NO.	ISSUED FOR ADDENDUM 1	REVISION/DESCRIPTION	ES	2008.12.05
			BY	DATE

PROJECT
 CONFEDERATION BUILDING
 SUPPLEMENTARY HEATING UPGRADES
 PHASE 1 - CITY BID OPP. NO. 757-2008
 457 MAIN STREET, WINNIPEG, MANITOBA
 SHEET TITLE
 BASEMENT LEVEL
 ELECTRICAL SINGLE LINE

SCALE	PROJECT NO.	SHEET NO.
AS SHOWN	105111	E02

ADDITION TO MAIN DISTRIBUTION

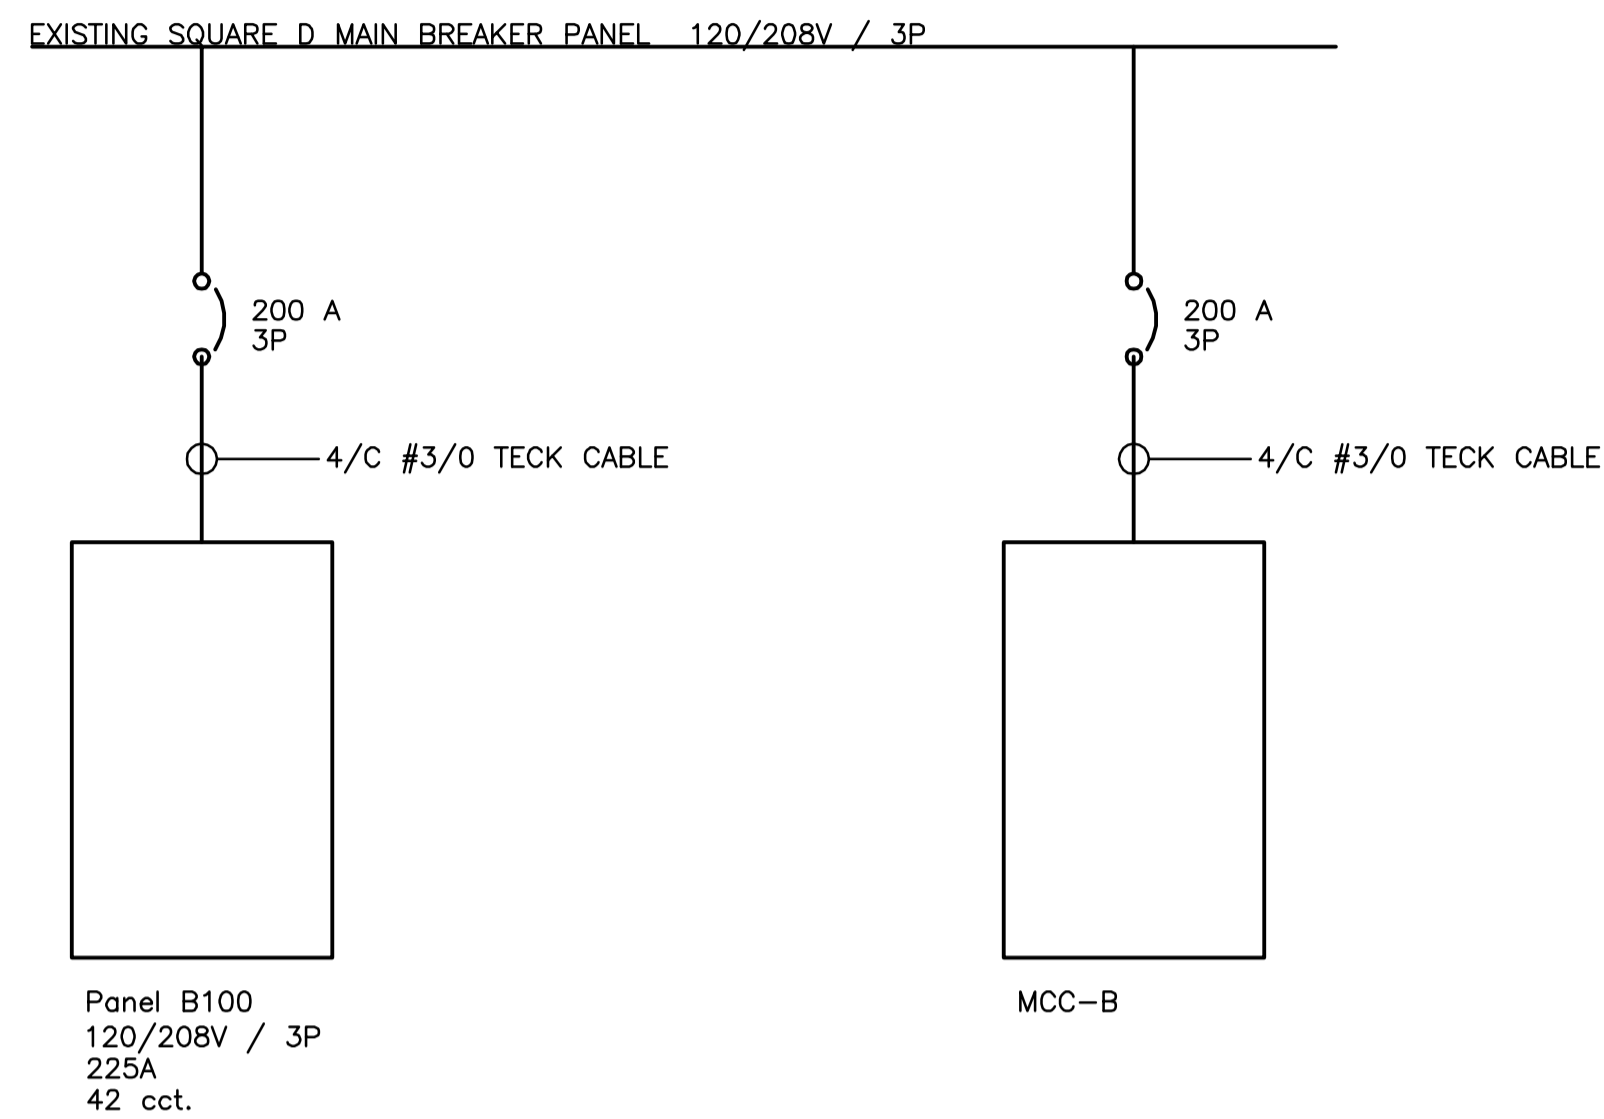
NOTES	
①	Replace existing breaker with new 30A breaker
②	VFD-1 supplied and installed by Div 23
③	Replace existing cable
④	In the disconnect switch, an "early-break" auxiliary set of contacts shall be interlocked with the VFD's Stop input
⑤	MUA-1 motor supplied and installed by Div 23
